**ADDENDUM NUMBER #2**

<u>PROJECT</u>	<u>BIDS DUE</u>
Village of Bellaire CWSRF Project #5910-01 WWTP Improvements GFA Project No: 24024	Date: June 24, 2024 Time: 9:00 AM Location: Village of Bellaire 202 N Bridge St., Bellaire, MI 49615

**VILLAGE OF BELLAIRE  
WASTE WATER TREATMENT PLANT IMPROVEMENTS  
BIOSOLIDS REMOVAL AND BERM REPAIR PLAN  
SECTION 30, T.30 N., R.7 W.  
VILLAGE OF BELLAIRE, ANTRIM COUNTY, MICHIGAN**

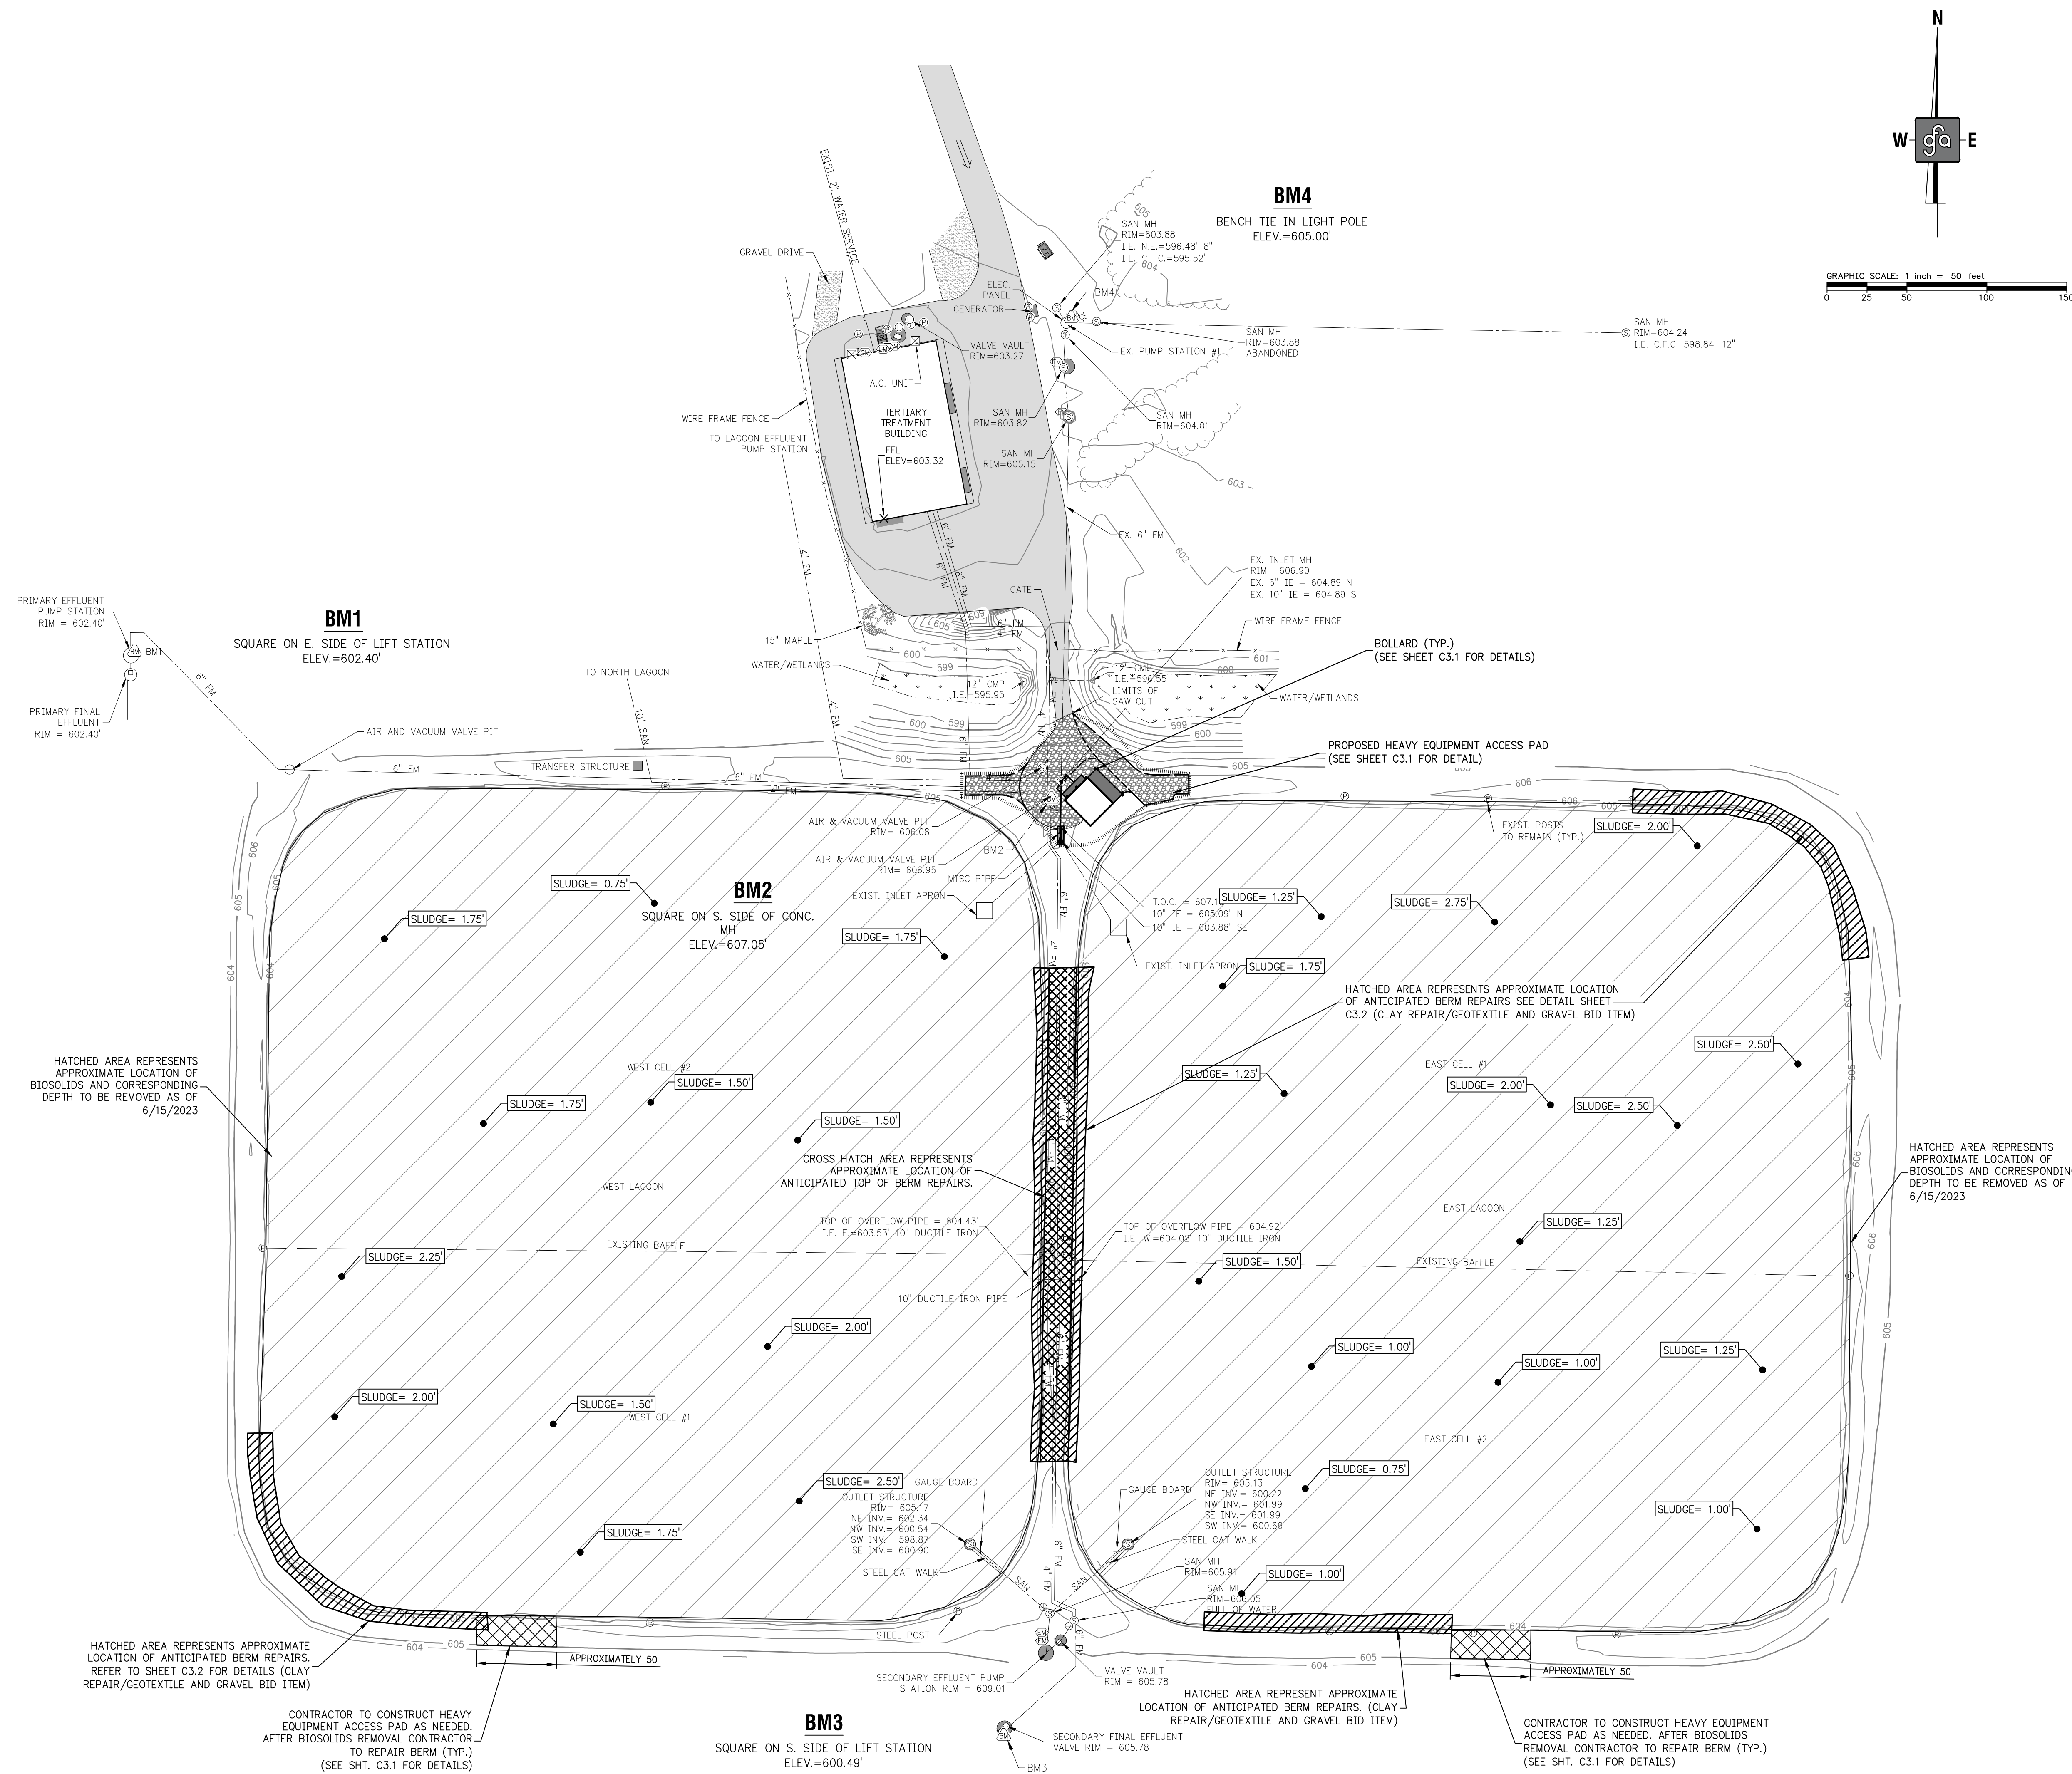
1. Sheet C2.3 has been updated and incorporated into this addendum and shall supersede the previous sheets. Updates include modifications to Clay Repair quantities and addition of Top of Berm Repair for clarification. Quantity of Clay Repairs line item includes entire hatched area, bidder to base extents of repairs off of Existing Berm Cross Section detail on sheet C3.2 and bidder to make assumptions to what the extent of repairs and restoration is pertinent to their trade.

## ELECTRICAL FLOOR PLAN

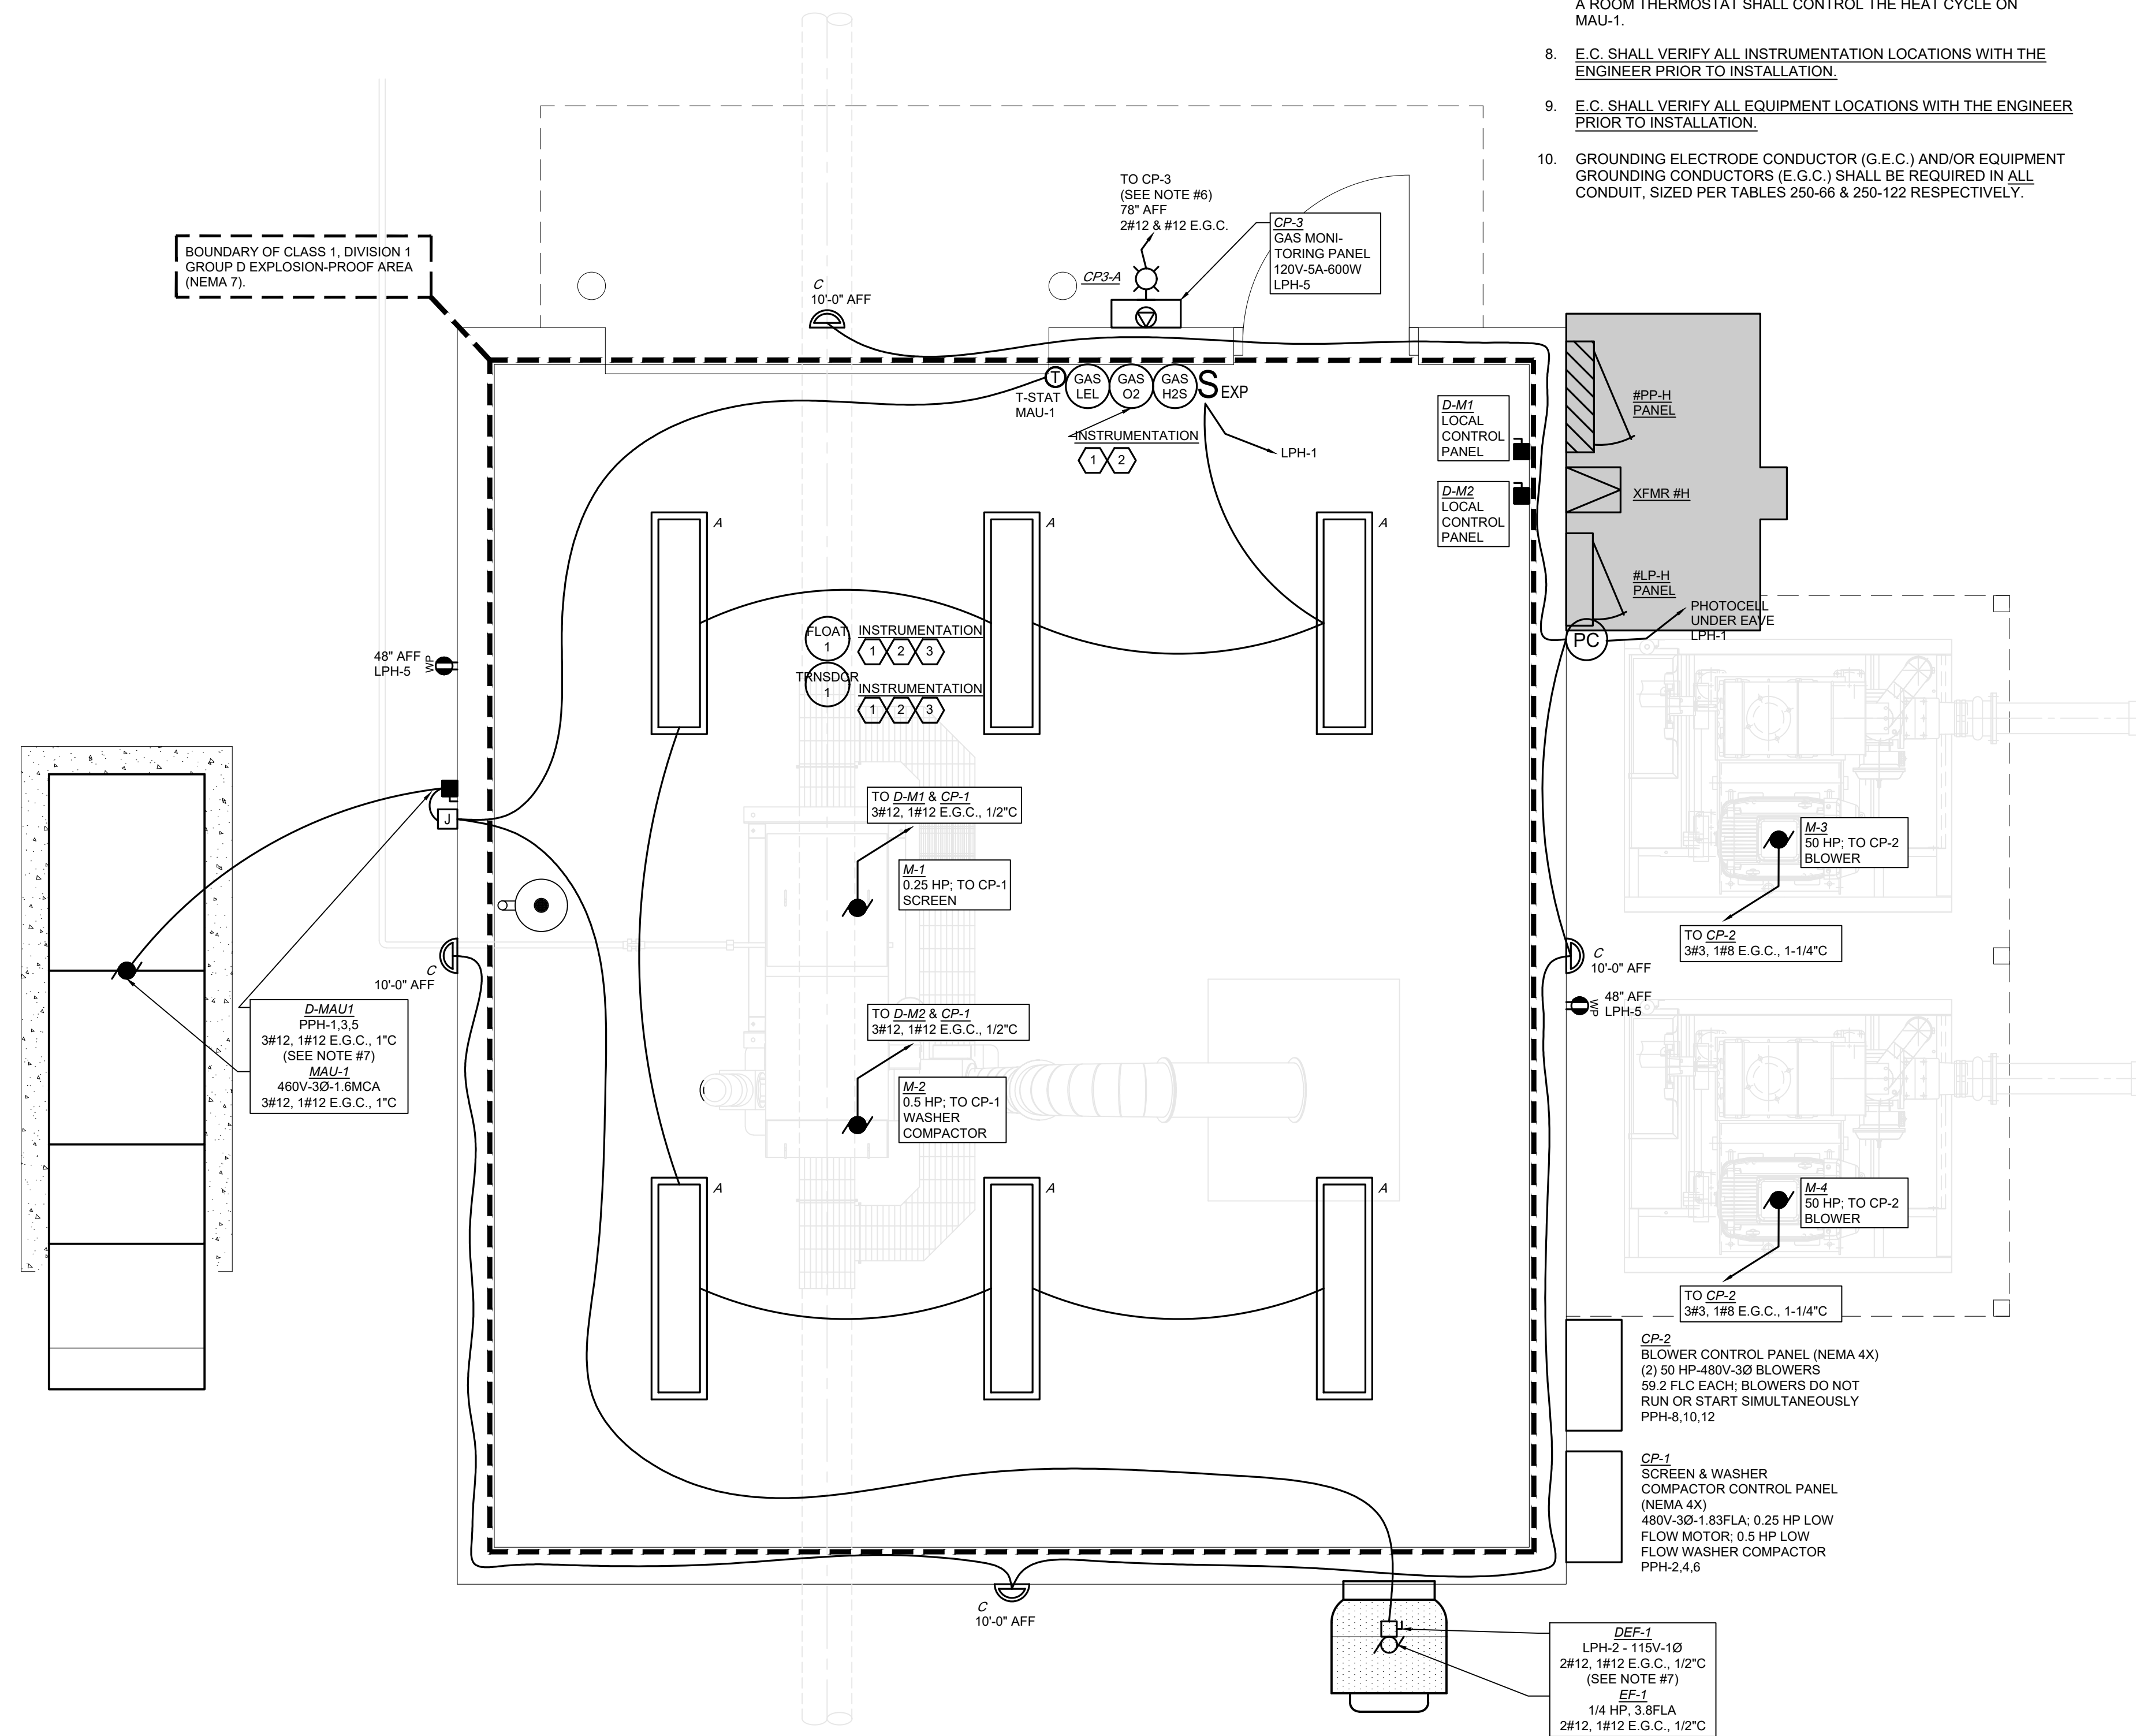
3. Sheets E1.1 has been updated and incorporated into this Addendum and shall supersede the previous sheets. Headworks Building influent channel instrumentation updates to include radar level transmitter and mechanical float switch as backup control.
